UNITED STATES PATENT AND TRADEMARK OFFICE

APPLICATION NO.	FILING DATE	FIRST NAMED INVENTOR	ATTORNEY DOCKET NO.	CONFIRMATION NO.
10/539,133	06/15/2005	Kazushi Wada	09792909-6288	2272
26263 7590 11/06/2007 SONNENSCHN NATH & ROSENTHAL LLP P.O. BOX 061080 WACKER DRIVE STATION, SEARS TOWER CHICAGO, IL 60606-1080			EXAMINER KUO, WENSING W	
			ART UNIT 2826	PAPER NUMBER
			MAIL DATE 11/06/2007	DELIVERY MODE PAPER

Office Action Summary

DETAILED ACTION

FIG. 1

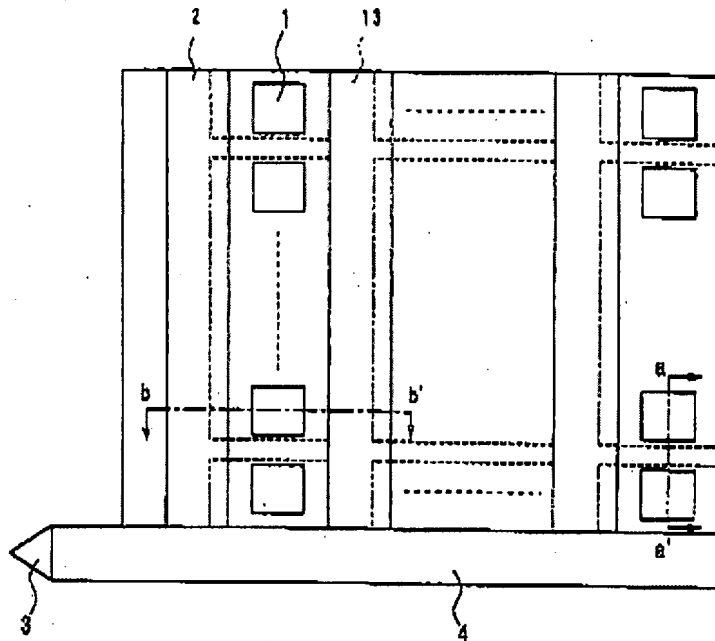
5. With respect to claim 1, Inagaki (e.g. Figure 1) teaches a solid state image pickup device having an image pickup region comprised of a plurality of photo-sensors 1 and a transfer register 2 for transferring signal charges accumulated in said photo-sensors (column 5, lines 49-51), said image pickup region formed on the face layer side (surface) (column 5, lines 41-46) of a substrate, wherein said solid state image pickup device further comprises:

an impurity region portion 13 (horizontal gridlines between adjacent photodiodes in vertical direction) formed continuously in a direction orthogonal to the transfer (vertical) direction of said transfer register (column 6, lines 39-52), said impurity region portion provided at a position corresponding to a position between said photo-sensors 1 adjacent to each other along the transfer direction of said transfer register in said substrate.

10. With respect to claim 7, Inagaki (e.g. Figure 1) further teaches a second barrier layer 13 (vertical gridlines between adjacent photodiodes in horizontal direction) (column 6, lines 39-52) comprised of an impurity region portion formed along said transfer register.

FIG. 2

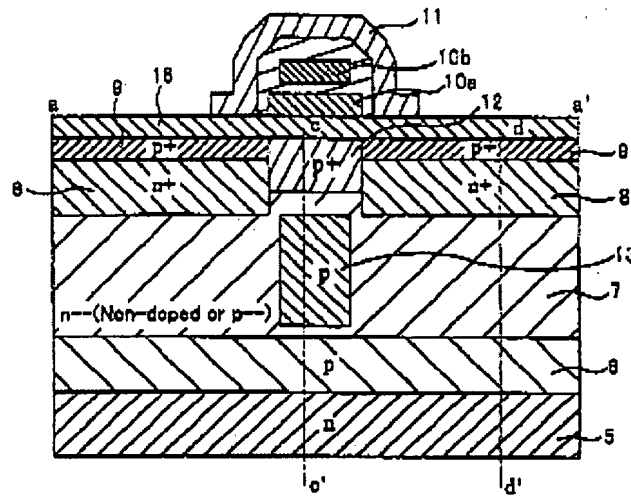
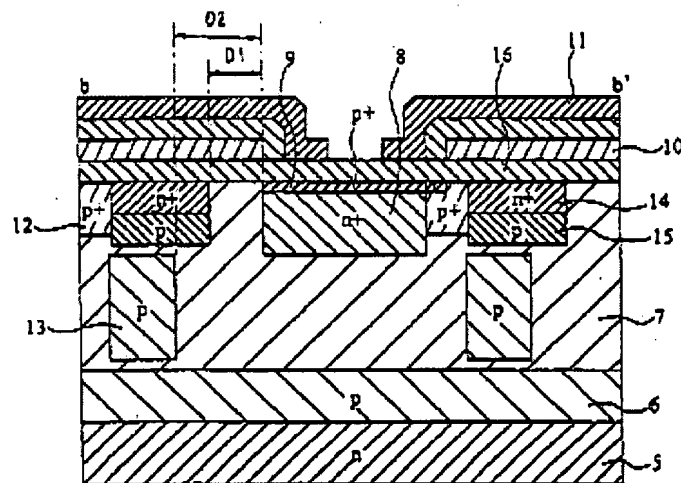
6. With respect to claim 2, Inagaki (e.g. Figures 2 and 3) further teaches that the impurity region portion 13 is formed at a position deeper than said transfer register (vertical CCD) (column 6, lines 2-4 and lines 39-42) as viewed from the face (surface) layer portion side of said substrate.

Inagaki (e.g. Figures 2 and 3) further teaches an overflow barrier 6 formed in said substrate on the deep layer portion side relative to said photo-sensors and said transfer register.
